**ZONING AMENDMENT
& SUBDIVISION STAFF REPORT****Date: April 4, 2013****APPLICANT NAME**

Cypress Lake Industrial Park Subdivision

AREA OF PROPERTY10 Lots / 72.6 ± Acres
Future Development Area: 284.7 ± Acres***Revised for the May 2 meeting:****8 Lots / 55.2 ± Acres
Future Development Area: 238 ± Acres***CONTEMPLATED USE**

SITE PLAN

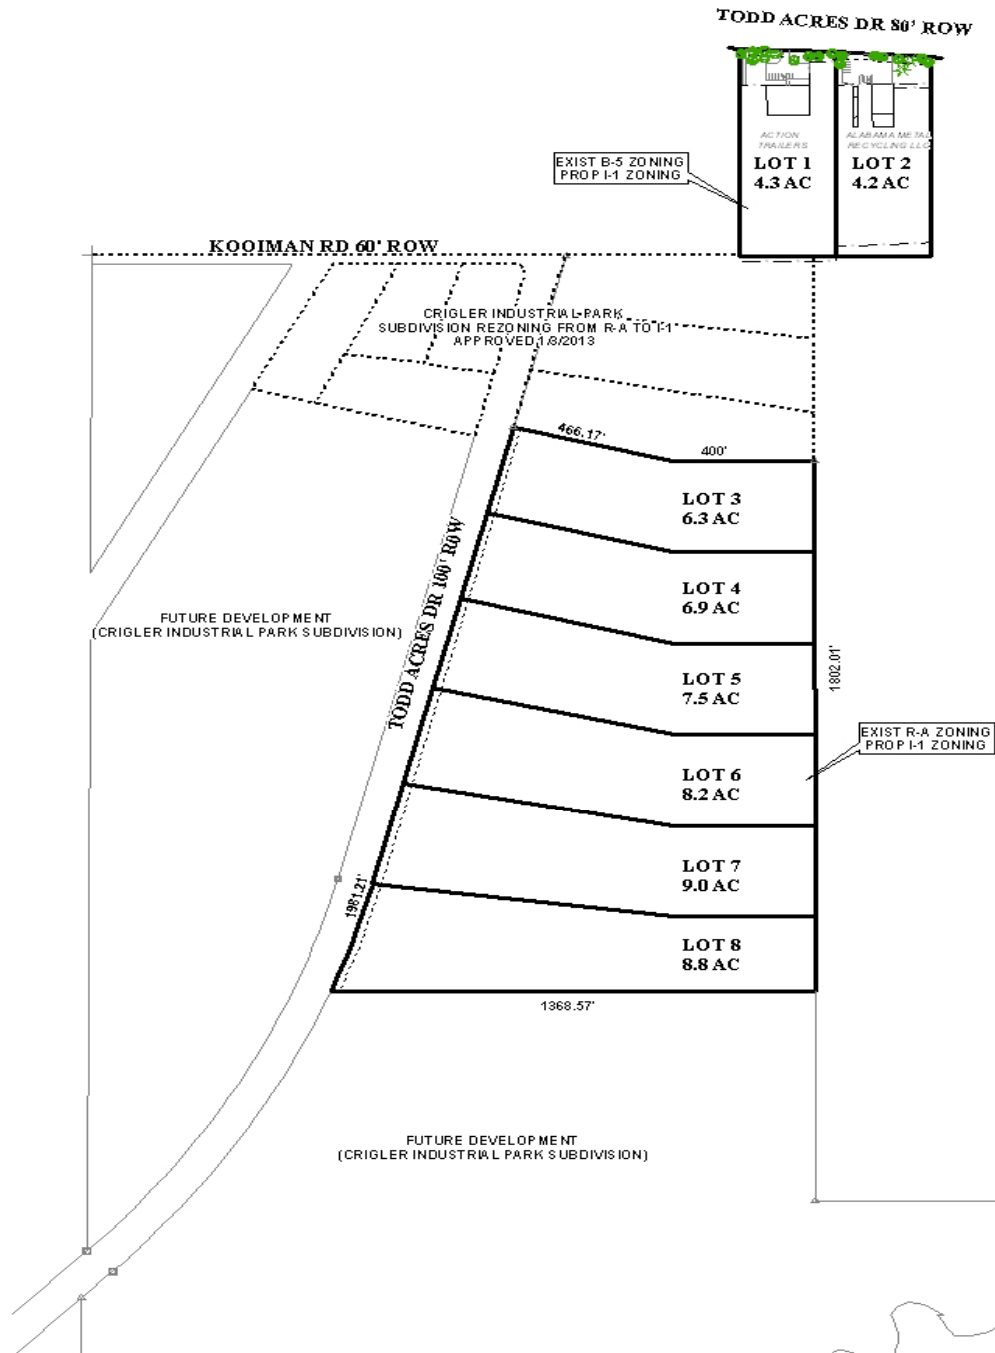
The current Zoning application indicates that the rezoning will be from R-A to I-1, yet the site plan provided with the application and the narrative show that two B-5 properties are also included in the rezoning request to I-1. The applicant should provide a revised application and narrative to accurately describe what is being requested.

The preliminary plat shows the proposed lots and two “future development” areas. The future development areas were also shown on the previously approved Crigler Industrial Park Subdivision, and the acreage of the application at hand should have been subtracted from the future development area: it appears that the acreage calculations are not correct and thus the preliminary plat is erroneous.

The 25-foot minimum building setback line is not depicted on the preliminary plat. The setback line should be depicted on the final plat, if approved.

It appears that the width to depth ratio recommended in Section V.D.3. of the Subdivision Regulations will be exceeded for proposed Lots 5-10. It appears that the maximum ratio will be 7.2 instead of the recommended 3.5 ratio. The depth to width request does appear to be excessive for several of the proposed lots, and as such, the applicant should consider the provision of a public or private street (with a Planned Unit Development) onto the property to

minimize oddly shaped lots that will make future development or re-subdivision problematic for future property owners. The applicant could also consider a resizing of several of the lots to reduce the ratio to more compliant levels.

As revised, the Zoning request reflects that two of the existing properties are B-5, and that the request is to change the zoning to I-1. The site plan depicts that each of the existing properties

can be brought into compliance with the frontage tree and landscaping requirements of the Zoning Ordinance for I-1 sites.

Finally, it appears that the legal descriptions on both the Zoning site plan and the Subdivision plat contain an error. The legal descriptions contain a reference to the West margin of Todd Acres, when in fact it should reference the East margin. The legal descriptions must be revised prior to any request to forward the Zoning information to City Council, and prior to the signing of the final plat.

- 1) Revision of the plat to eliminate or minimize lots exceeding the width to depth ratio recommended in Section V.D.3. of the Subdivision Regulations, or revision of the plat to provide a public or private street to serve the larger lots;

- 2) Revision of the plat to correctly identify the acreages for “future development” areas, so that the proposed Cypress Lake plat reflects the approved but not yet recorded Crigler Industrial Park plat;

- 3) Revision of the plat to depict and label the minimum 25-foot front setback line;
- 4) Placement of a note on the final plat/site plan stating that approval of all applicable federal, state and local environmental agencies for wetlands or floodplain issues is required prior to the issuance of any permits or land disturbance activities;

- 1) Revision of the legal description to correctly identify the area within the Subdivision;
- 2) Placement of a note on the final plat stating that Lots 1 and 2 are limited to two (2) curb-cuts each, and that Lots 3-8 are limited to one (1) curb-cut each, with the size, design and location to be approved by Traffic Engineering and to conform to AASHTO standards;
